SUBJECT: **Safety Recall 15S08**
Certain 2008-2010 Model Year F-250 / F-350 Super Duty Vehicles
Serviced with Steering Gear DC3Z-3504-D (STG-454)
Steering Gear Mounting Spacer Installation

CERTAIN 2008-2010 MODEL YEAR F-250 AND F-350 F-SUPER DUTY VEHICLES SERVICED WITH STEERING GEAR DC3Z-3504-D (STG-454) — STEERING GEAR MOUNTING SPACER INSTALLATION

FIGURE 2

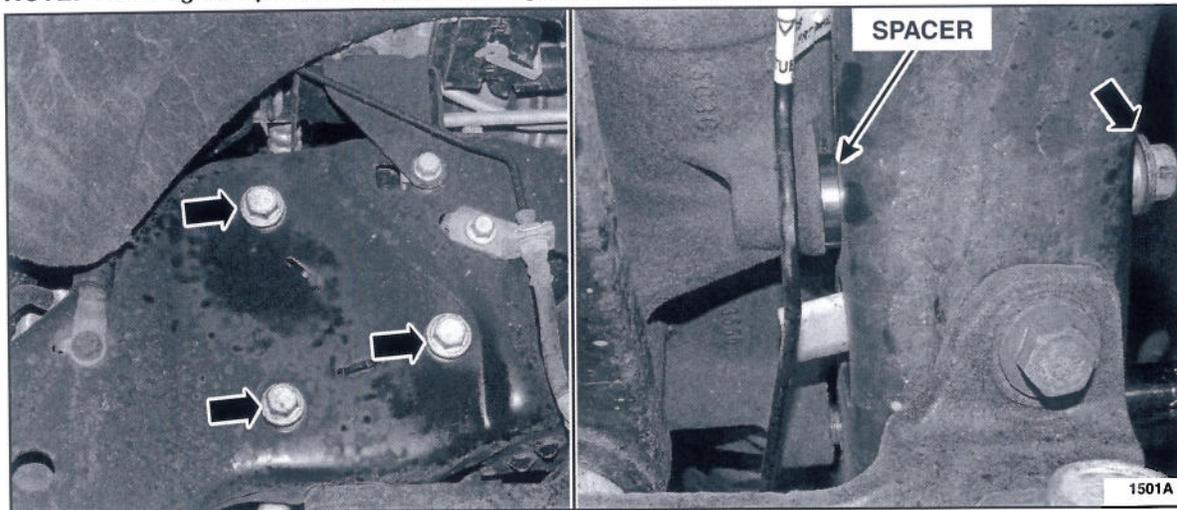
1. Remove the LH front wheel and tire assembly from the vehicle. Please follow Workshop Manual (WSM) procedures in Section 204-04.
 - Ensure that the steering wheel is in the straight ahead position so that Step 5 (clear vision adjustment) can be performed with more accuracy.
2. Loosen the three steering gear retaining bolts so that the steering gear can be pried away from the frame, allowing room to insert each spacer. See Figures 1 and 2.
3. Remove one original bolt and install a *new* bolt and spacer as shown. Replace the remaining original bolts with *new* bolts and spacers one at a time to keep the steering gear in place. **DO NOT REUSE THE ORIGINAL BOLTS.** See Figure 2.

FIGURE 3

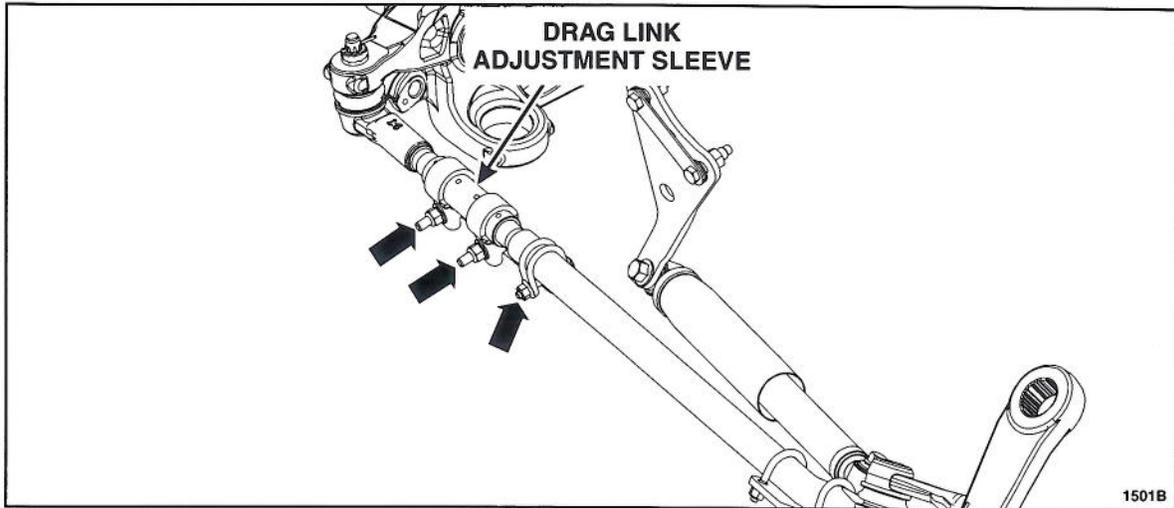
4. Tighten the *new* steering gear bolts.
 - F-250/350 vehicles - 165 Nm (122 lb-ft).
5. Loosen the drag link adjustment sleeve fasteners and adjust the sleeve as needed to obtain proper steering wheel clear vision. See Figure 3.
 - Tighten the drag link adjustment sleeve bolts to 55 Nm (41 lb-ft).
